RE: Planning Commission Agenda Packet for December 15, 2021 Regular Meeting

- a. **SP 21-01 – Dollar General, T-20-01-395-005, Final Site Plan Review** – Dollar General is seeking final site plan approval for the construction of a 9,100 square foot retail store and associated site improvements. Our review has been updated based on the revised plan submitted since the November Planning Commission meeting. All outstanding planning issues have been addressed.
- b. **SLU 21-01 Railsplitter #2 – Special Land Use - Multiple Properties.** An application has been received for a special land use for large-scale solar project north of Arkona, south of Talladay, east of Sanford and west of Gooding encompassing thirteen (13) parcels and 478 acres of land. A pre-application conference was conducted at the April 2021 Planning Commission meeting. A public hearing was conducted at the September 2021 Planning Commission meeting.

Subject: **Site Plan Review Responses**

DOLLAR GENERAL STORE #22731
AUGUSTA, MICHIGAN
10467 WILLIS ROAD

MONUMENT SIGN 32.00 SQ. FT.

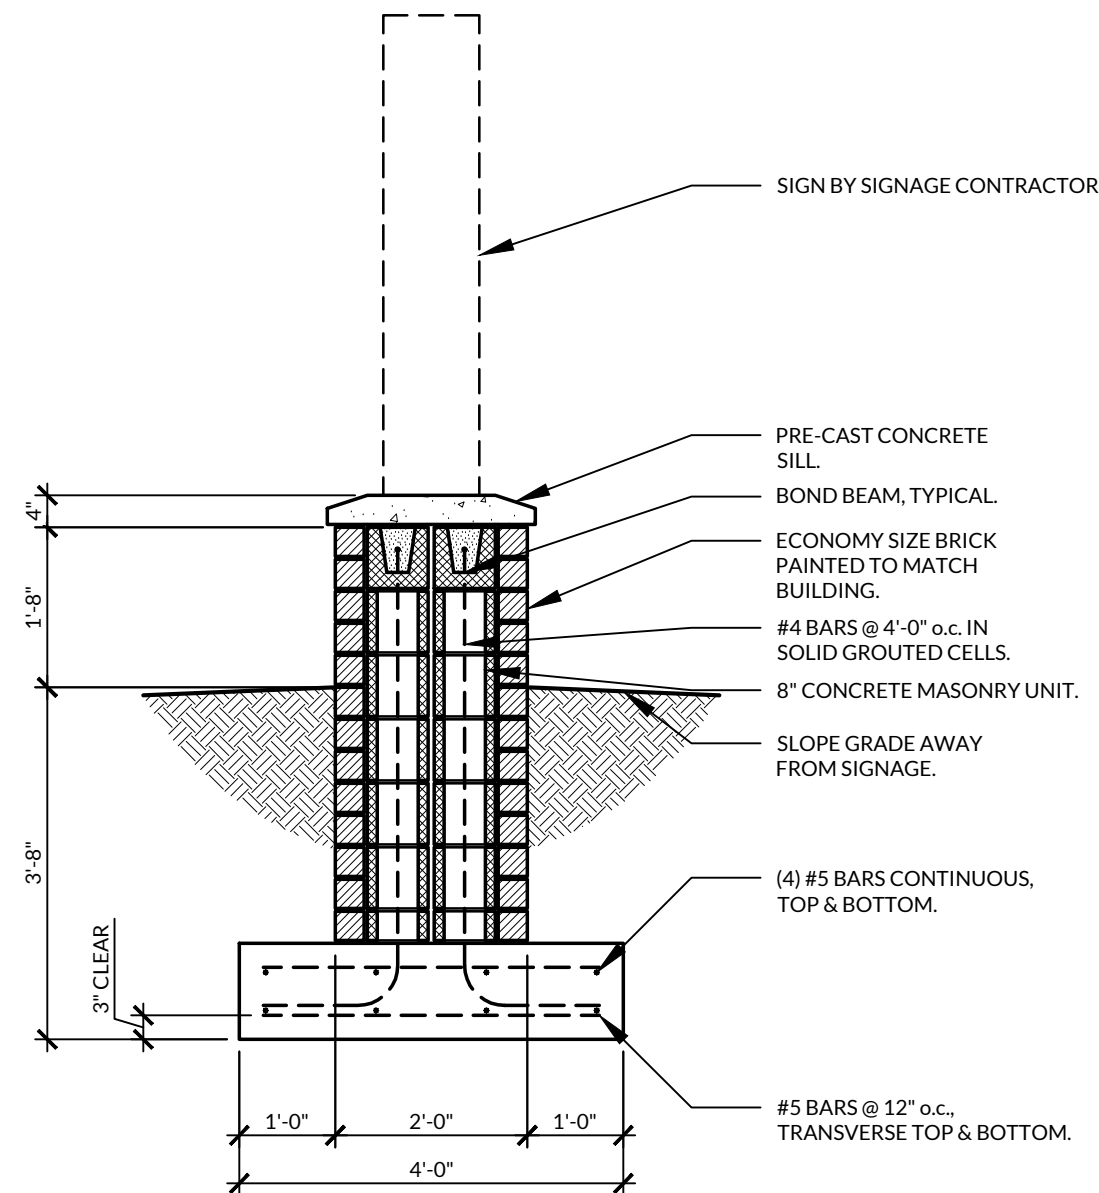
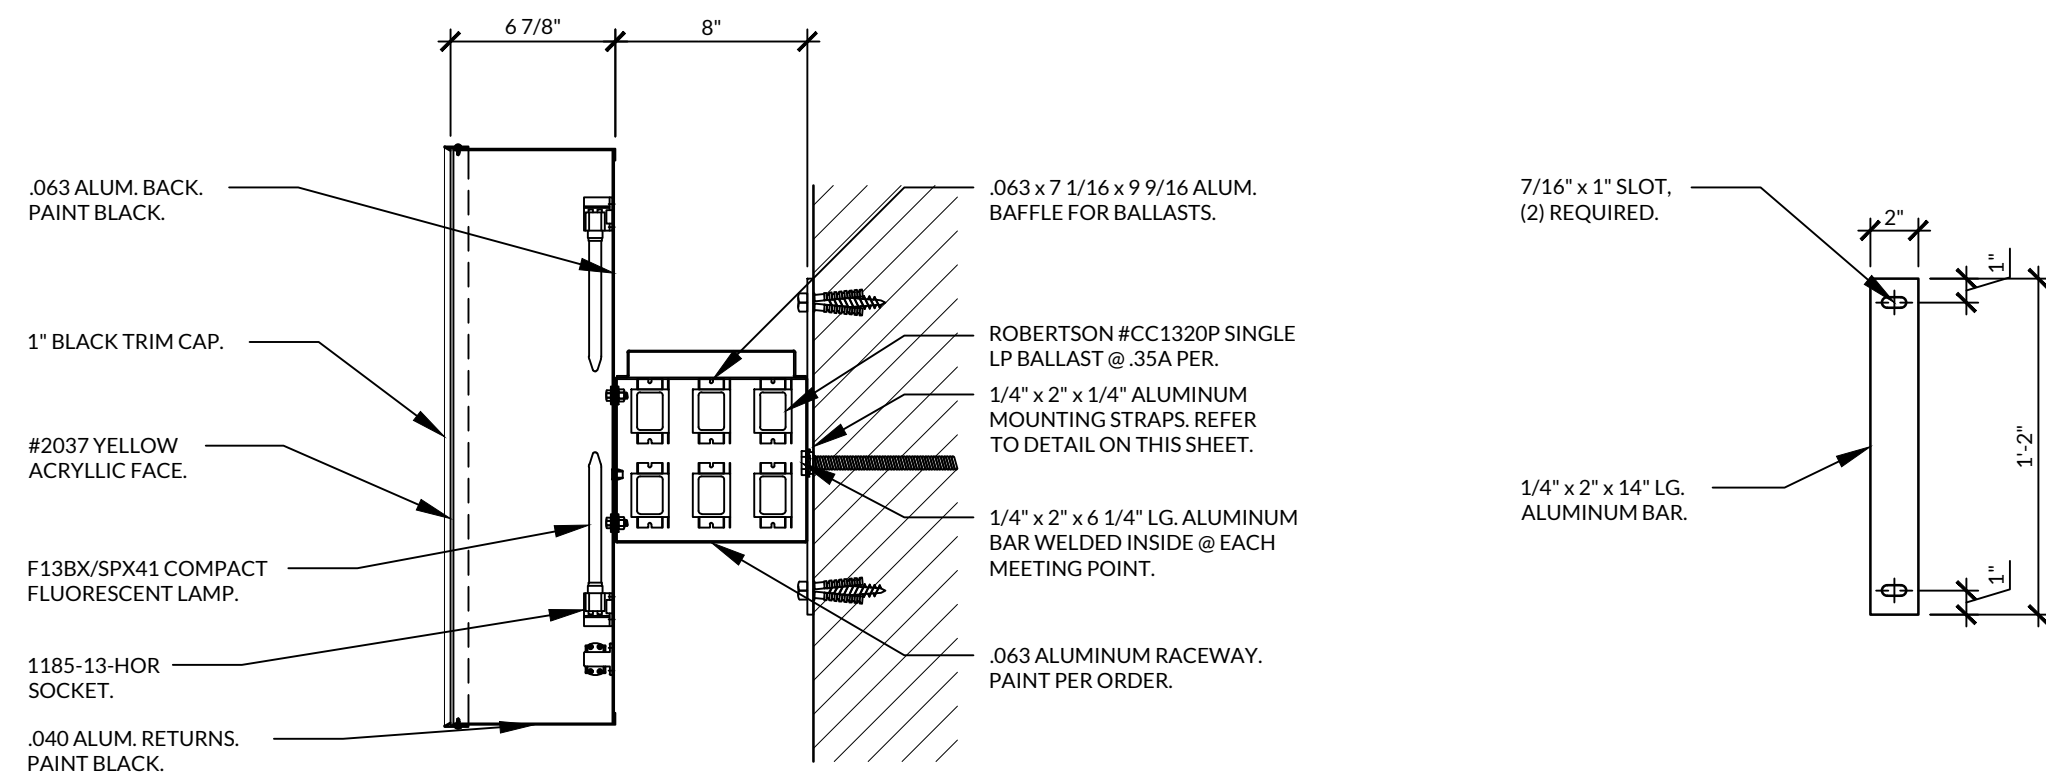
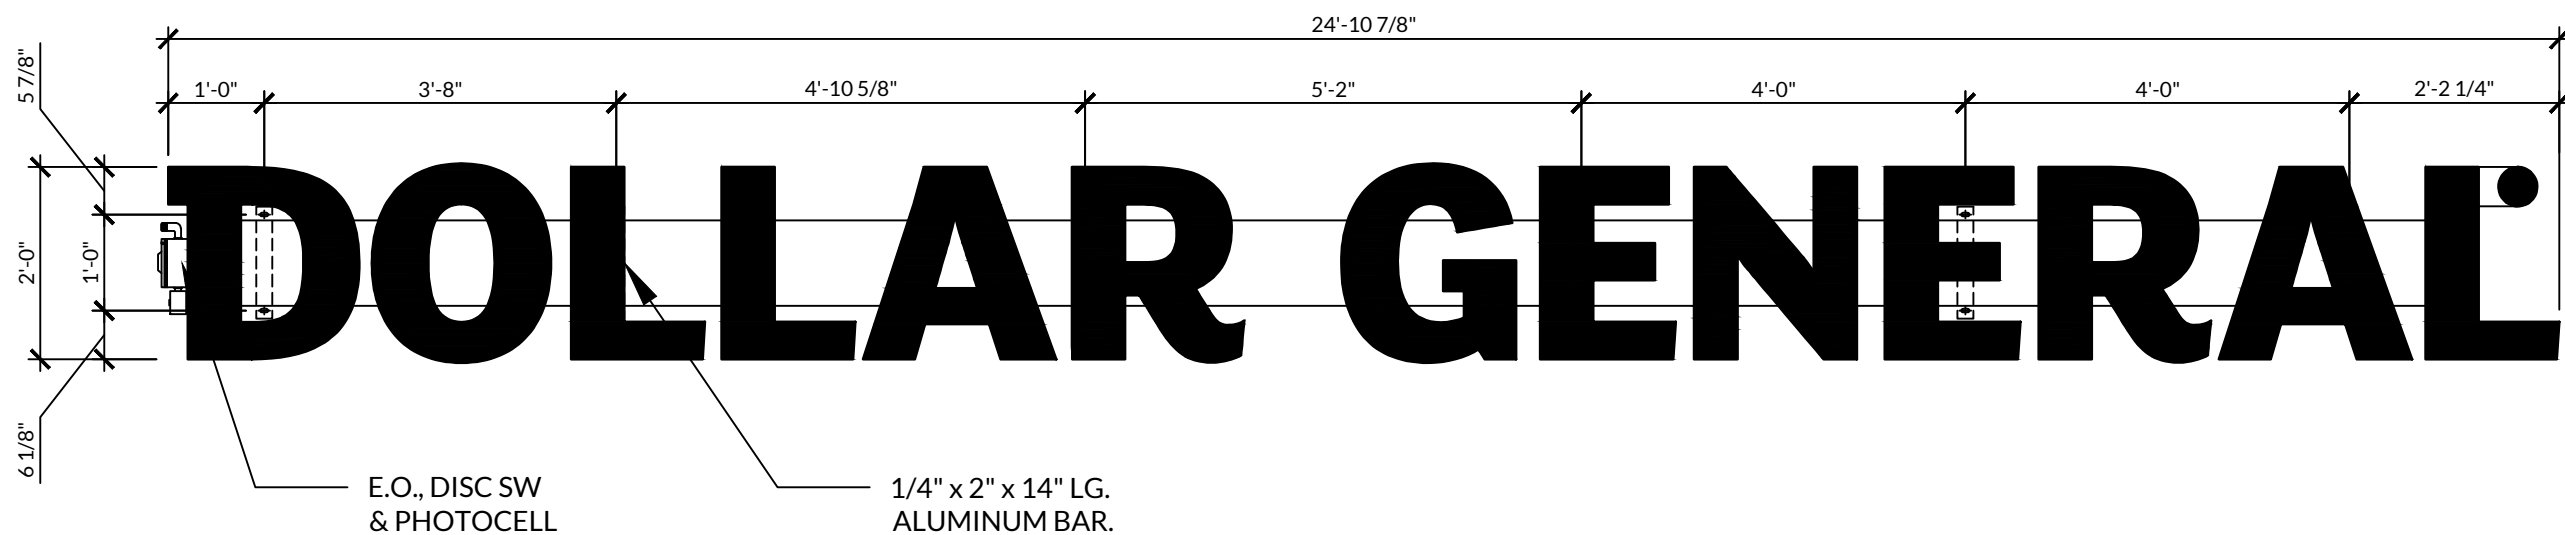
Sign details are provided on Sheet A7.1 noting the size of both freestanding and wall signage areas. Freestanding signs are limited to one-half (0.5) of a square footage per linear foot of lot frontage, but in no case shall exceed 32 square feet in area. Based on the frontage of the lot the maximum 32 square feet of freestanding signage is allowed. The applicant is proposing a 32 square foot freestanding sign. Further, freestanding signs are limited to 6 feet in height, and dimensions on Sheet A7.1 verify height of the sign will not exceed 6 feet in height.

A wall sign is also proposed, and detail is provided on Sheet A7.1. Wall signs shall be based on one (1) square foot of area per one (1) foot of linear building frontage with no wall signs to exceed

A temporary construction sign is also proposed on Sheet A7.1. The location of this sign is not provided nor is the overall sign height. Temporary signs that advertise the construction of new non-residential development shall not exceed 32 square feet in area or 6 feet in height. These temporary signs shall be removed immediately after construction is complete.

5. Demonstrate location of freestanding sign in relation to Willis Road future right-of-way.
-Dimensions have added to Sheet C1
6. Reduce size of freestanding sign to 32 square feet.
-Dimensions have added to Sheet C1 and the signage plan has been revised.

7. Provide detail of sign base and overall sign height (maximum 6 feet).
-Please see sheet A7.1. Sign base details & overall sign height added.
8. Reduce size of wall sign to 60 square feet.
-Please see sheet A7.1. Wall sign revised to meet 60s.f. max requirement.

E5

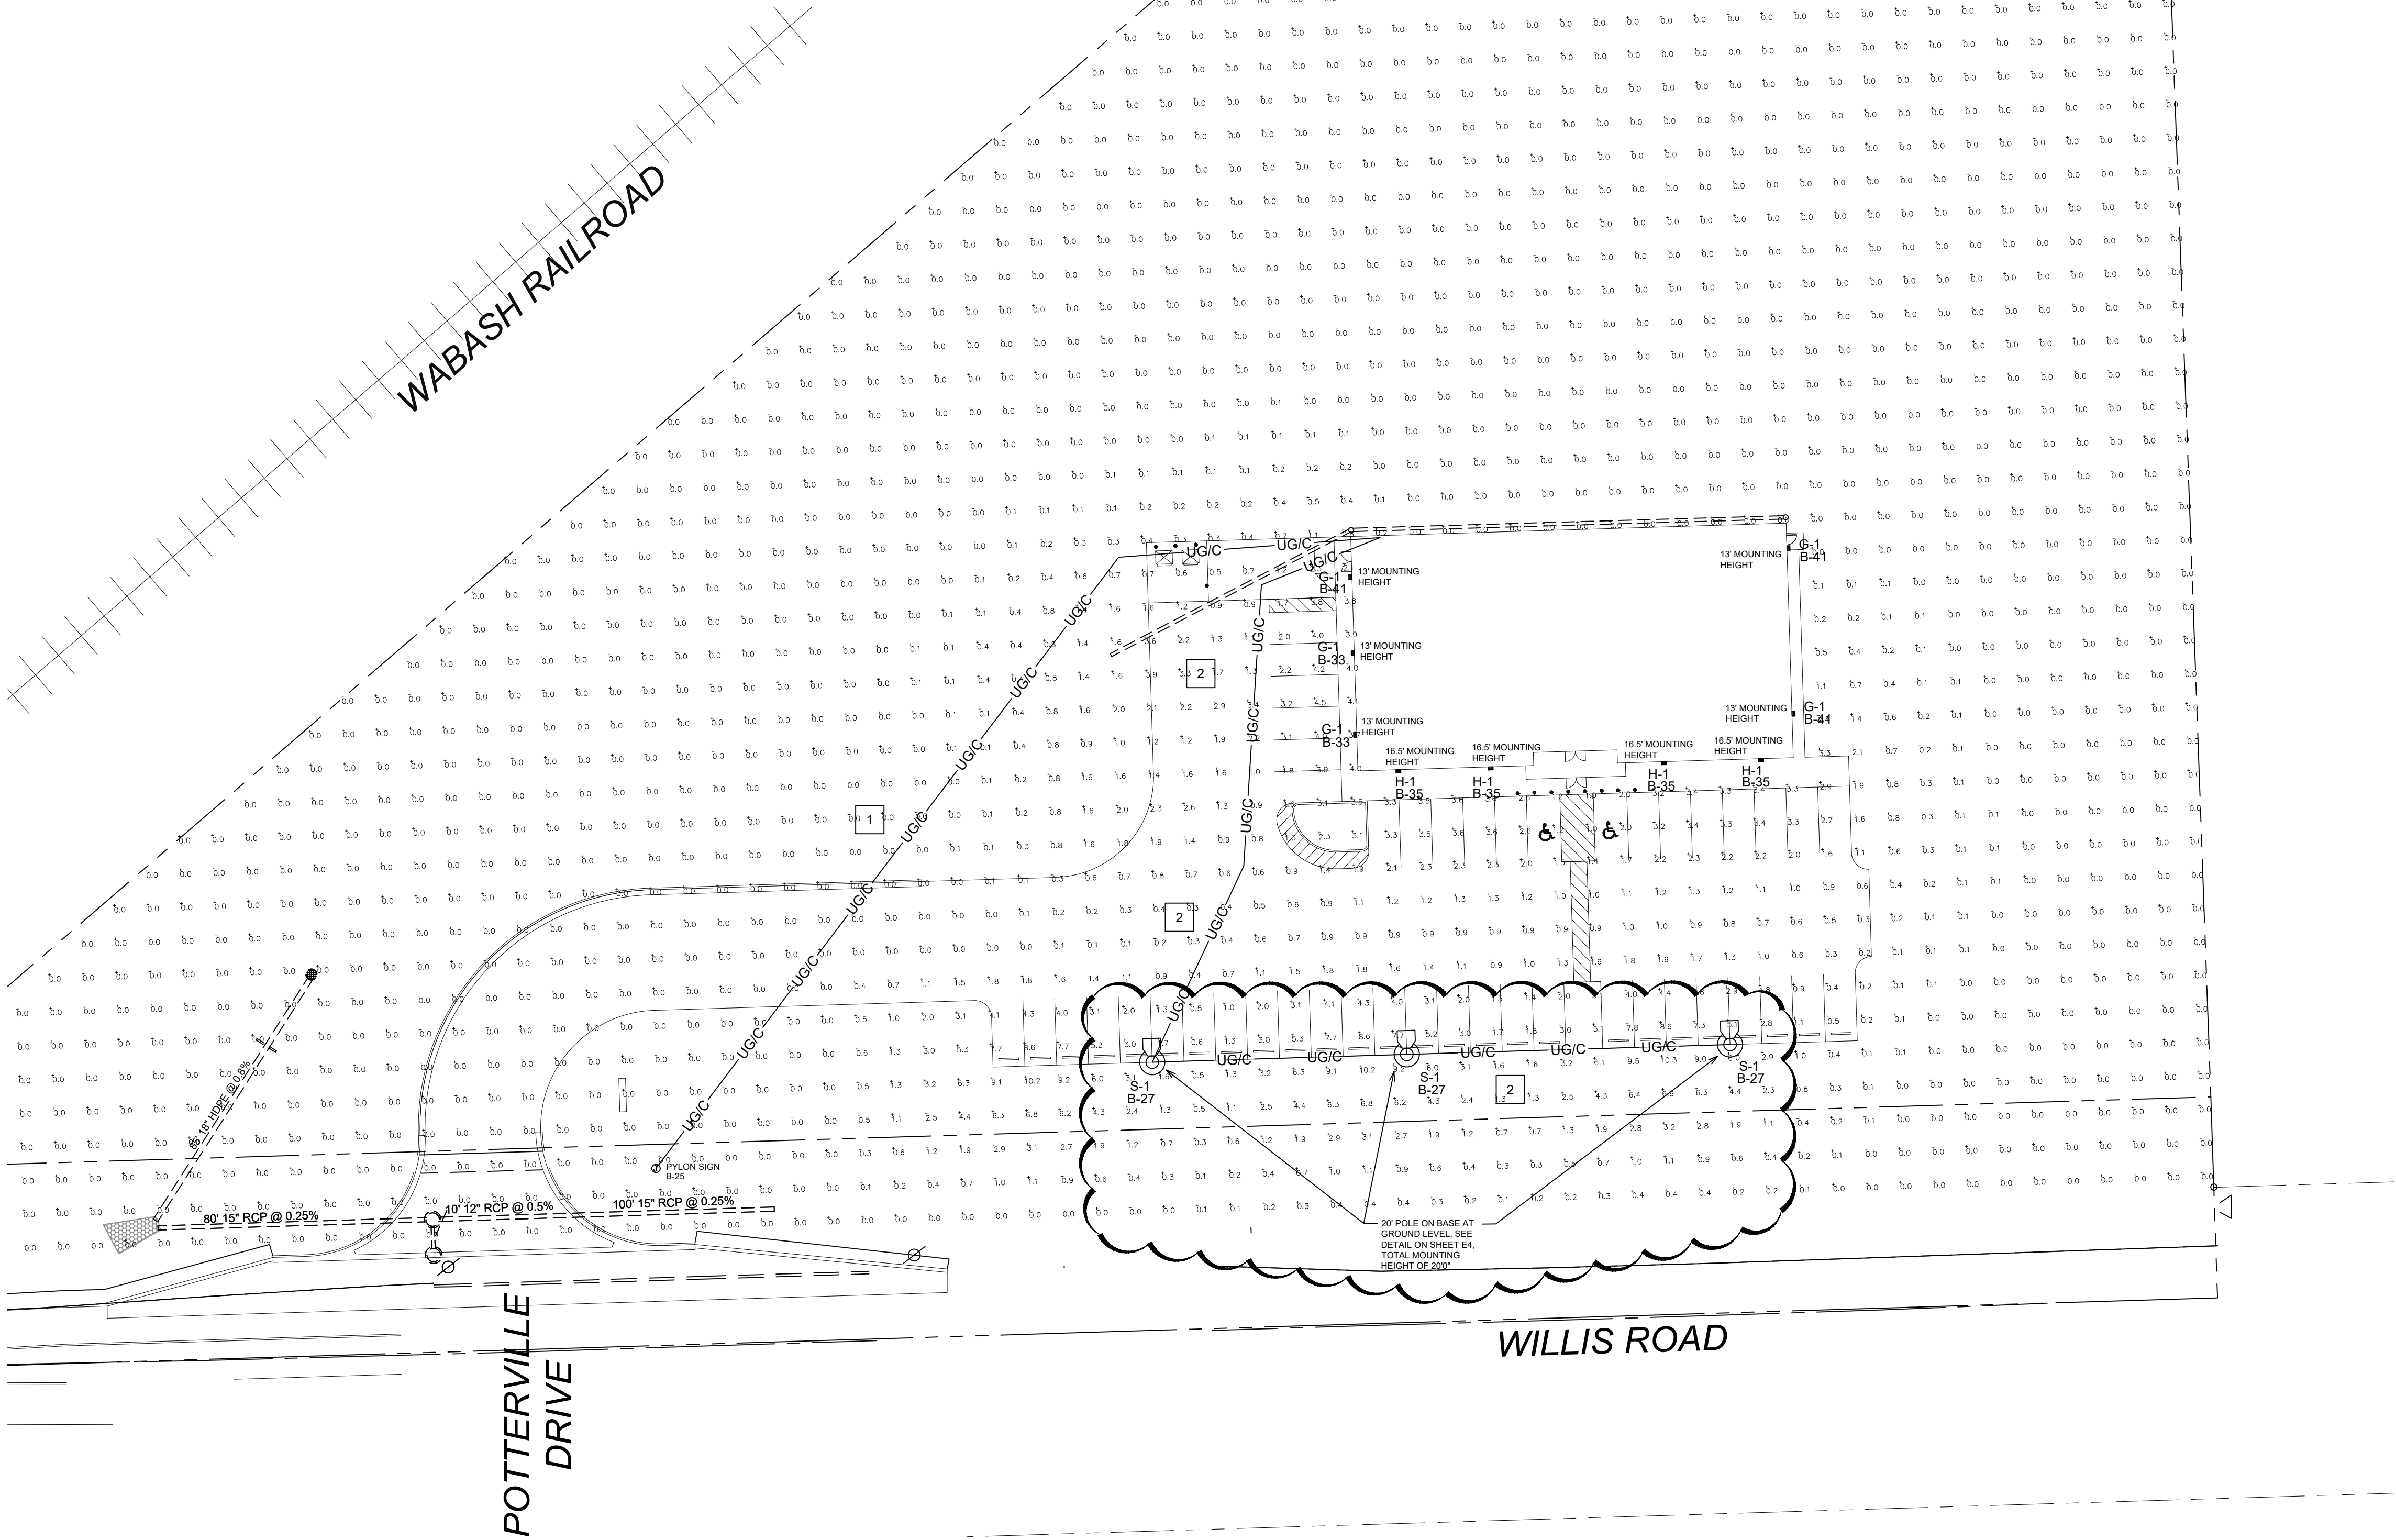
2. *Maximum light pole height is indicated on your response to be 22.5-feet total height. This will need to be reduced to 20 feet which is the maximum light pole height allowed.*

A lighting plan is provided on Sheet E5. We note the location of all proposed wall-mounted and pole-mounted fixtures and illumination levels are noted on the plan. Additionally, mounting heights of wall-mounted fixtures are called out. Detail of proposed fixtures has been provided in the second revised submittal demonstrating they are fully shielded and downward directed. Further, the height and detail of pole-mounted fixtures has been provided depicting a 20-foot pole-mounted fixture as allowed..

Overland Engineering Response: See Revised Sheet E5 and new E7, E8, E9, E10 for Lighting Specs.

3. Provide height of pole-mounted fixtures.
-See revised Sheet E5, Total height is 22.5'
4. Provide detail of all proposed light fixtures.
-See revised Sheet E5 fixture schedule & Product Line catalog for detail.
